SUBDIVISION REVIEW SHEET**CASE NO.:** C8-2009-0058.0A**Z.A.P. DATE:** July 20, 2010**SUBDIVISION NAME:** Resubdivision of Lot 3, Block E, Westover Hills Section 4, Phase 2**AREA:** 0.434 acres**LOTS:** 2**OWNER/APPLICANT:** Stephen & Ellyn Yachtman**AGENT:** Aupperle Co.
(Bruce Aupperle)**ADDRESS OF SUBDIVISION:** 4201 Hyridge Drive**GRIDS:** H-31**COUNTY:** Travis**WATERSHED:** Bull Creek**JURISDICTION:** Full Purpose**EXISTING ZONING:** SF-3**PROPOSED LAND USE:** Single Family**SIDEWALKS:** Sidewalks are required along Hyridge Drive prior to the lots being occupied.**DEPARTMENT COMMENTS:** The request is for approval of the re-subdivision, namely, Resubdivision of Lot 3, Block E, Westover Hills Section 4, Phase 2. The proposed resubdivision is composed of 2 lots on 0.434 acres.

TO: Sylvia Limon, Case Manager
CC: Bruce Aupperle, P.E., Aupperle Company
FROM: Amber Mitchell, Senior Planner
DATE: July 13, 2010
SUBJECT: Transportation Staff Recommendation for the Resub of Westover Hills, Sec 4 Ph 2

CITY OF AUSTIN –DEVELOPMENT SERVICES DEPARTMENT
SUBDIVISION APPLICATION – MASTER COMMENT REPORT

PROJECT NAME: Westover Hills Section Four Phase Two Resubdivision of Lot 3 Block '
LOCATIO

Proposed Plat

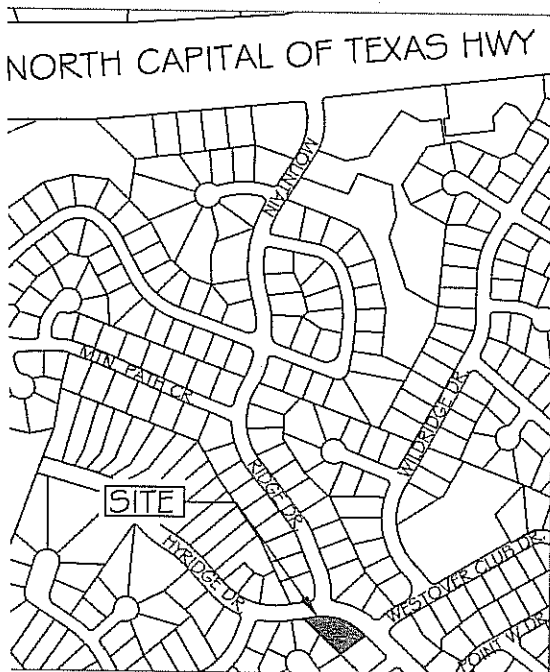
Stopping sight distance is the distance necessary for a driver to perceive a situation requiring a stop, apply the brakes, and come to a stop. Were direct vehicular access approved for Lot 3A, there would not be enough stopping sight distance along Hyridge Drive for a vehicle to make a safe left turn and exit the driveway. The table below compares the City’s stopping sight distance standards with those provided by the proposed subdivision.

Stopping Sight Distance	Left Turn from Lot	Right Turn from Lot
City Standard (based on 30 mile per hour posted speed limit on Hyridge Drive)	335'	290'
Proposed Driveway (Lot 3A)	180'	280'

The applicant has offered to grade the subdivision and remove all trees and landscaping within the sight line to improve sight distance to the proposed lot. This will require the removal of a 24’ multi-stem protected live oak tree and will only provide a maximum left turn sight distance of 235’, 100’ less than the City standard.

The Transportation Review Section does not recommend this subdivision because vehicular access from the proposed lot will not meet the City’s stopping sight distance standards.

If the Zoning & Platting Commission approves this subdivision, staff requests that the following requirements be added to the subdivision:

1. The driveway for Lot 3A shall be designed as a hammerhead, so that drivers leaving the lot are not required to back into the street.
2. The driveway for Lot 3A shall be located as far east as feasible on the lot, as depicted on the applicant's sight distance exhibit.
3. Both lots within the subdivision shall be graded and all fencing and all landscaping along and within the right of way and within the subdivision shall be removed so that as much sight distance as possible is provided.

Please note that due to the grading required to improve sight distance for the proposed lot, approval of the subdivision is considered approval for the removal of the 24" protected-size live oak tree. Mitigation in the form of payment into the tree fund will be required for this removal.
